MHI's Response to US-APWR DCD RAI No.792-5928 Revision 3 (SRP 18) Subject:

US-APWR Design Certification

18.5- STAFFING AND QUALIFICATIONS

QUESTION NO.: 18-140

Figure 18.1-2 Operations Personnel Staffing and Organization (Minimum)

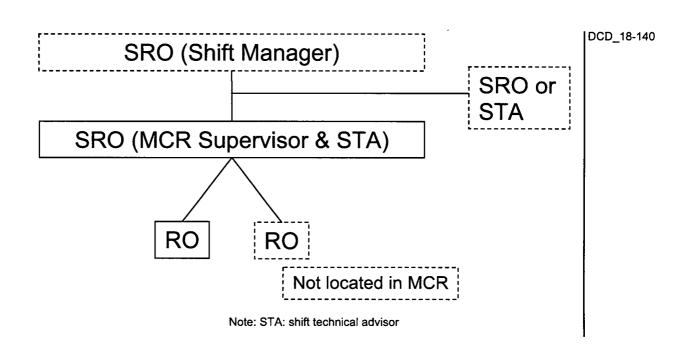
The response with regard to the role(s) of the SRO/STA, the staff finds the response does not provide sufficient information to address the staff concerns. The Shift Supervisor and STA responsibilities are not sufficiently defined for abnormal control room operations so that the staff can be assured the SRO/STA working in the dual role will be able to successfully perform both duties. The staff requests additional justification describing how the Shift Supervisor will be able to perform the functions of the STA (as described in Generic Letter 79-61); and show that he is capable of all other concurrent duties during accident conditions such as interim site emergency director, communicating with the off-site organizations, company organizations, etc., while maintaining vigilance on the emergency plan which is in constant need of evaluation during an accident. Additionally, the shift supervisor, will likely be filling the interim site emergency director role for greater than one hour during the initial implementation of the emergency plan; until the emergency response organization is manned and he is relieved as emergency director. Explain how he can provide insight to the operating crew as STA during this time.

In consideration of staff comments, and for consistency with IN 93-81 and GL 79-61, and consistency with US practices in current operating plants, the minimum operator staffing levels for the US-APWR will be changed as follows:

- 1 SRO located at the plant fulfilling the role of Shift Manager
 - The combined role with STA will be deleted, to avoid concurrent duties during emergency conditions. The position name of Shift Supervisor will be changed to Shift Manager for consistency with operating plants and to avoid confusion with MCR Supervisor. The MCR Supervisor reports to the Shift Manager.

- 1 SRO located within the MCR fulfilling the role of MCR Supervisor and STA
 - operations (abnormal conditions are discussed below). To fulfill this role the MCR Supervisor will have both SRO and STA qualifications. This combined role is consistent with IN 93-81 which emphasizes "the need for engineering expertise in the control room" and "the STA will have an active role in shift activities". This is also consistent with many operating plants in the US. It is noted that in some US-APWR documents the MCR Supervisor is also referred to as the Shift Supervisor or Control Room Supervisor. Erroneous references to Shift Supervisor will be changed to Shift Manager.

- 1 additional SRO or STA at the plant
 - This is a new position, not previously described. This person, with either of these qualifications, will relieve the MCR Supervisor of his combined SRO/STA duties, allowing a single focus during emergency conditions. This will place a separate MCR Supervisor and STA in the MCR during emergency conditions. Since this new person is required to be at the plant, but not continuously in the MCR, this person can be shared by multiple units.
